## Belmont Planning Board

## Memorandum Regarding

**91 Beatrice Circle:** Chapter 40B Comprehensive Permit Application

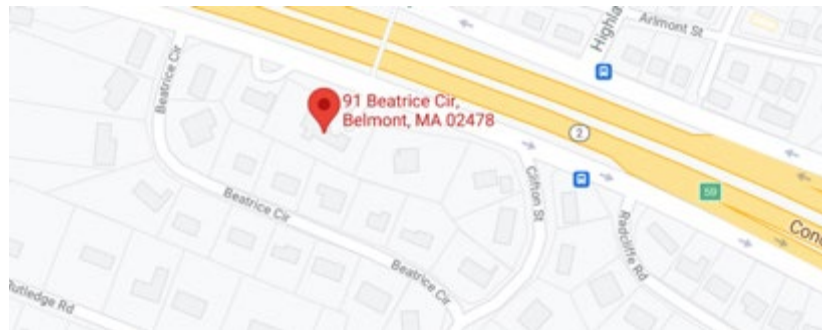
The Frontage Road is one-way, two lanes wide, with a walkway but no buffer:

The current driveway to the Location can be seen on the right. A pedestrian footpath to

Arlington is on the left. There is a bus stop at the street lamp.

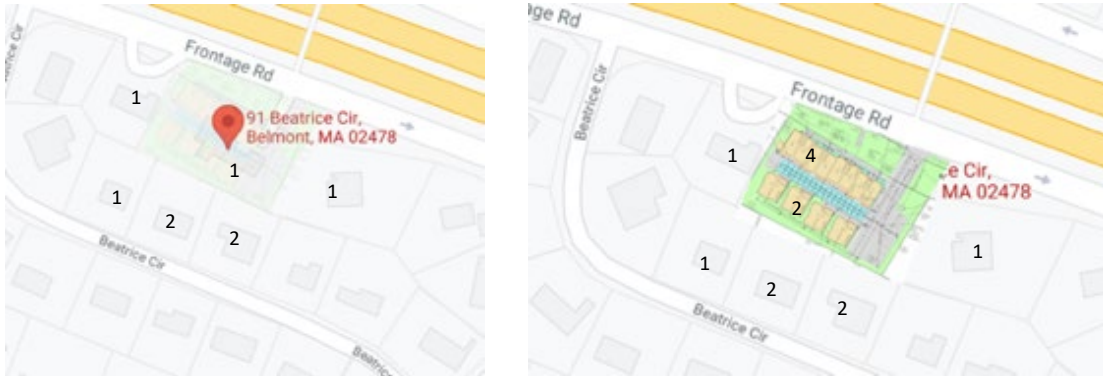
Part of assessing neighborhood fit is the impact on abutters, and whether that is disproportionate. The impact here is extremely disproportionate.

The Location has a significant grade going down from West to East.

From the West, although it is above the Location, the added building height would nevertheless obstruct the view and, given the proximity to the property boundary, loom over the property in a way not otherwise reproduced in the neighborhood.

The following gives a sense of the impact on the abutter to the West (the number of stories visible from the road are indicated).
